## Circuit Analysis Report

Test IC	ATmega128RFA1	
Crystal	Holder	NX2520SA
	Frequency	16.000MHz
	Load capacitance	CL=8pF[IEC] (Current) <b>CL=10pF[IEC] (Suggested)</b>
	NDK Spec. No.	STD-CSW-5(J) (*J:CL=10pF[IEC])
Test Circuit	IC	MEGA128RFA1-ZU 1105D 0T6227
	VDD	+3V / +1.8V
	PCB	TB1_MEGA_RF AVR2067 - Crystal Characterization for AVR RF

### 2. CIRCUIT DIAGRAM

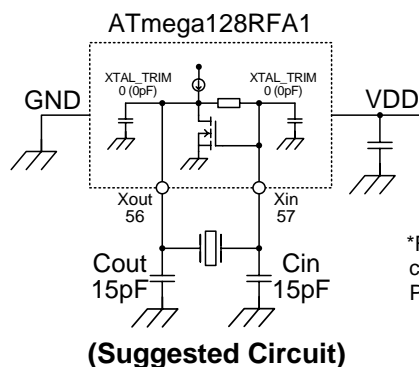
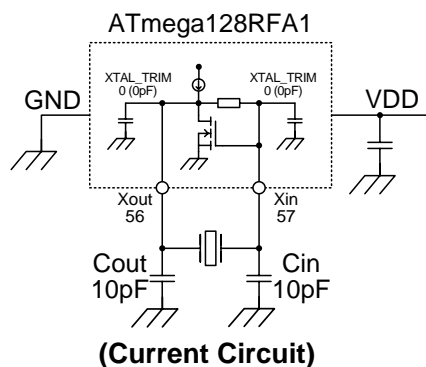
- 1) This crystal unit requires negative resistance of  $-R = 900\Omega$  minimum for stable oscillation
- 2) Circuit characteristics

Circuit	Cout/Cin	XTAL_TRIM (Internal Cap)	Frequency deviation dF/F	Negative Resistance -R	Drive Level DL	Startup time Tstr
Current	10pF/10pF	0 (0pF)	+4ppm (CL=8pF[IEC])	3290 $\Omega$	Less than 10uW	2.5ms
Suggested	15pF/15pF	0 (0pF)	<b>-4ppm (CL=10pF[IEC])</b> Ref.: -22ppm (CL=8pF[IEC])	1750 $\Omega$	Less than 10uW	3ms

- 3) Although the negative resistance of the current circuit is over our target, it seems too large.
- 4) In order to improve negative resistance, we recommend changing external capacitance values from Cout/Cin=10pF/10F to **Cout/Cin=15pF/15pF**. Besides, we recommend changing crystal load capacitance value from CL=8pF to **CL=10pF** in order to improve frequency deviation.
